## T10/04-030r4, SAS-1.1: Fix SP Hang States

To: T10 Technical Committee  
From: Robert Sheffield (Robert.L.Sheffield@intel.com), Intel Corporation  
Date: June 16, 2004  
Subject: T10/04-030r4, SAS-1.1: Fix SP Hang States

Replace figure 69 – SP (phy layer) state machine – speed negotiation states with the following figure:

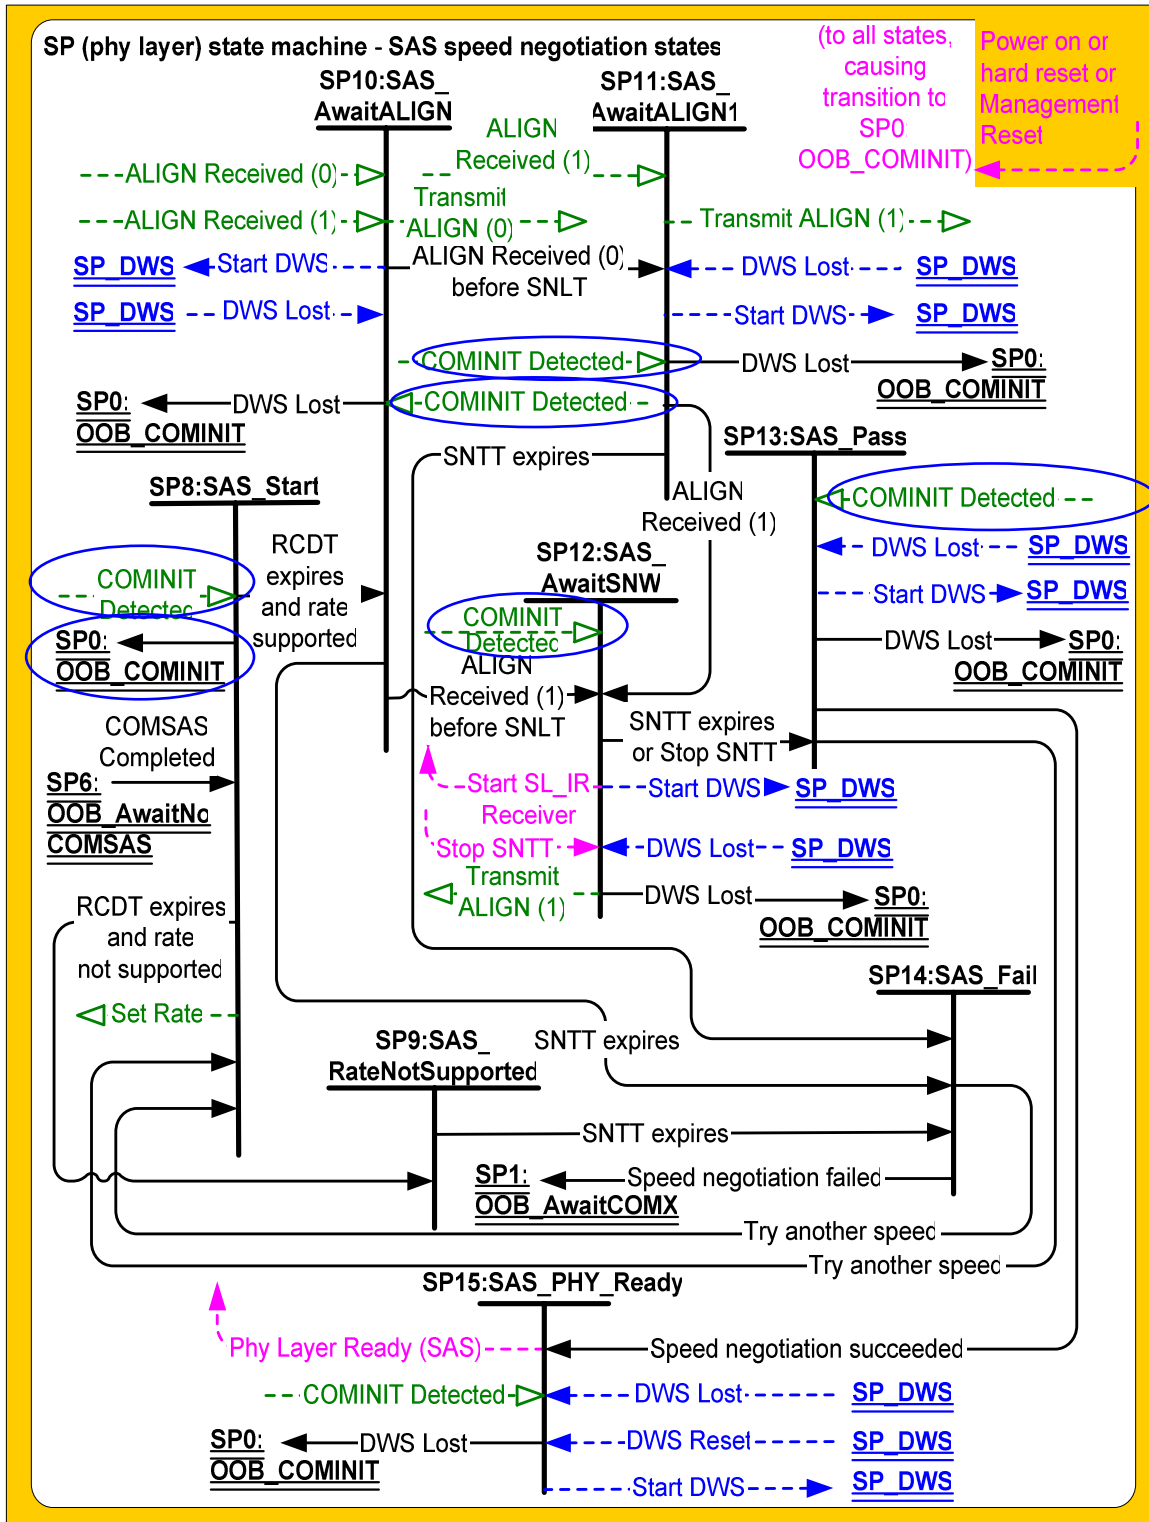
*Modify subclause 6.7.3.9 as shown to replace the transition to SP0, with a transition to SP26 for spinup-hold, and to specify use of the MgmtReset bit:*

**6.7.3.9.2 Transition SP7:OOB\_AwaitCOMSAS to SP26:SATA\_SpinupHold**

This state shall send a SATA Spinup Hold confirmation to the link layer and this transition shall occur if,

- a) this phy is in an expander device;
- b) this phy supports attachment to a SATA device;
- c) the COMSAS Detect Timeout timer expires;
- d) this expander device implements SATA spinup hold; and
- e) the value of the MgmtReset machine state variable is zero.

**6.7.3.9.4 Transition SP7:OOB\_AwaitCOMSAS to SP16:SATA\_COMWAKE**

This transition shall occur if:

- a) the phy supports attachment to SATA devices; and
- b) the COMSAS Detect Timeout timer expires; and
- c) the value of the MgmtReset state machine variable is one.

Figure 72 — SP (phy layer) state machine – SATA Spinup Hold State

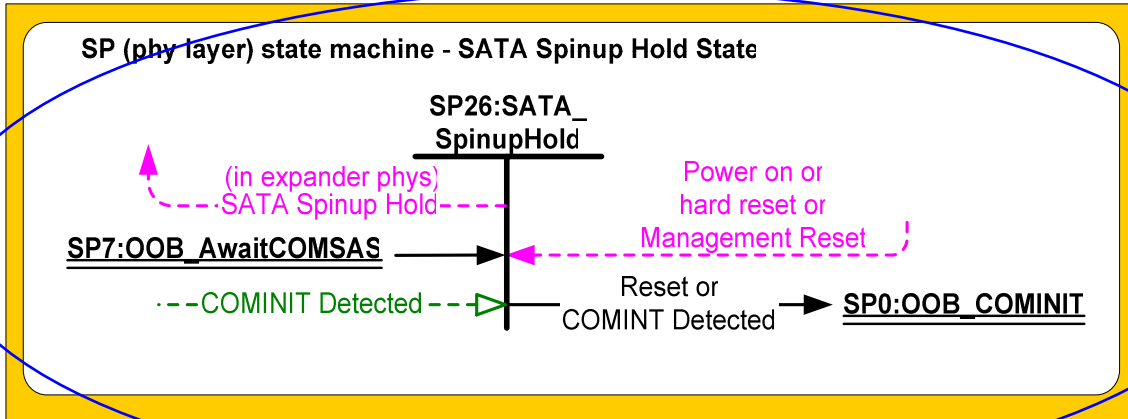
Figure 72 shows the SP26:SATA\_SpinupHold state. This state shall be entered from the SP7:OOB\_AwaitComsas state upon detection of a COMSAS detect timeout if the phy supports SATA, the phy supports Spinup Hold, and the MgmtReset state machine variable has a value of zero.

This transition shall occur if this state receives a COMINIT Detected message, a Management Reset request from the management layer, a hard reset, or a power on. If this transition is caused by a Management Reset Request from the management layer, it shall cause MgmtReset to be set to one upon entry to SP0:OOB\_COMINIT. Otherwise, MgmtReset shall be set to zero upon entry to SP0:OOB\_COMINIT.
